**Report: TAB Report**  
**Function: Test, Adjust, & Balance**  
**Date: 01/11/2026**  
**Completed By: National TAB**

**01-05-26 Wawa #5462 Jacksonville, FL**

**Issue Name :** Curb Leak - All RTUs  
**Description :** All RTUs have a curb leak in the location shown. It is moderate on RTU3, and less noticeable on RTUs 1 and 2  
**Created By :** National TAB                      **Assigned To :** National TAB - Dan Hertenstein  
**Status :** Open  
**Priority :** High                                      **Asset Tag :**  
**Originated Date :** 01/08/2026 - Jackson Gunnels - National TAB

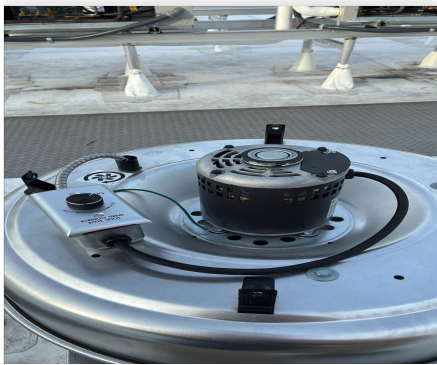
**Issue Name :** EF-1 Dampers  
**Description :** Could not locate dampers for women’s restroom and one of the back of house exhausts. Unable to fully balance grills on this unit.  
**Created By :** National TAB                      **Assigned To :** National TAB - Dan Hertenstein  
**Status :** Closed  
**Priority :** Urgent                                      **Asset Tag :**  
**Originated Date :** 01/07/2026 - Jackson Gunnels - National TAB

- **02/04/2026 National TAB - Jackson Gunnels**
  - Dampers located, issue resolved.

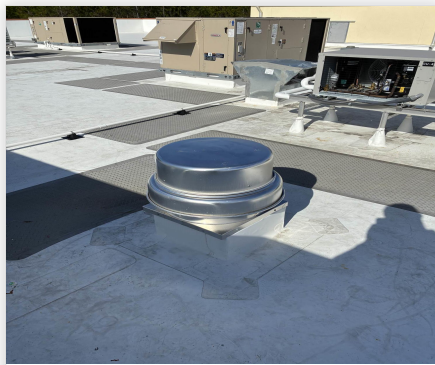
**Issue Name :** EF-1 Total Flow  
**Description :** EF1 at max flow only provides %92 design flow. Approximately 70 cfm total change from lowest to maximum setting on speed controller.  
**Created By :** National TAB                      **Assigned To :** National TAB - Dan Hertenstein  
**Status :** Closed  
**Priority :** Urgent                                      **Asset Tag :**  
**Originated Date :** 01/08/2026 - Jackson Gunnels - National TAB

- **02/04/2026 National TAB - Jackson Gunnels**
  - Further diffuser balancing resulted in greater total flow from EF-1, now at %95 of design, issue resolved.

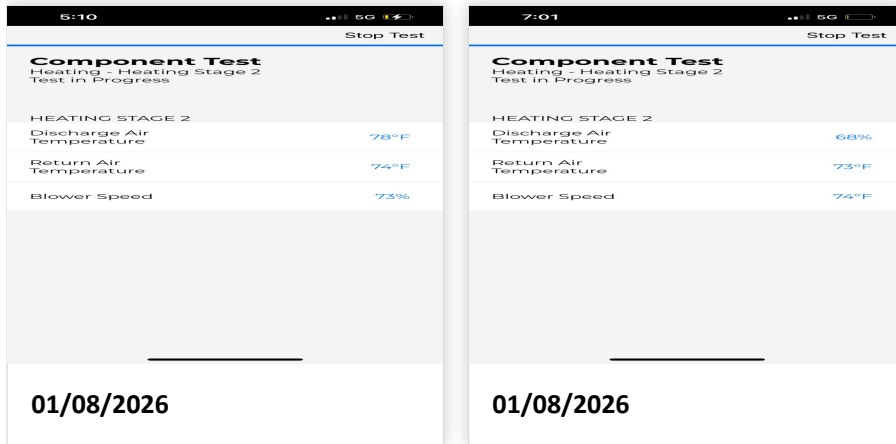
**Issue Name :** RTUs 1 and 3 Heating  
**Description :** Unable to confirm heating functionality on RTUs 1 and 3. Unit 1 EAT/LAT 78/74, unit 3 EAT/LAT 74/73.  
**Created By :** National TAB      **Assigned To :** National TAB - Dan Hertenstein  
**Status :** Closed  
**Priority :** Urgent      **Asset Tag :**  
**Originated Date :** 01/08/2026 - Jackson Gunnels - National TAB

- **02/04/2026 National TAB - Jackson Gunnels**
  - Confirmed heating functionality on both units. Unit 1 EAT/LAT 72/80 Unit 3 EAT/LAT 80/71. Return temperatures began increasing at 80 degrees.

Asset: EF-1

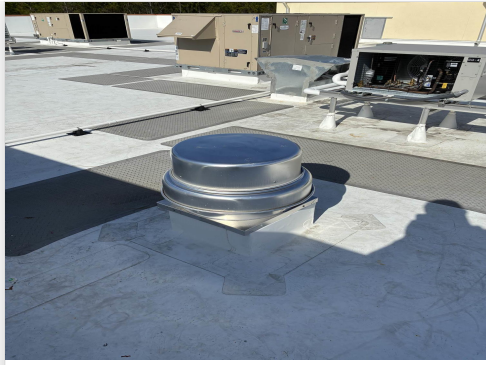
Notes:  
Speed controller at maximum setting.
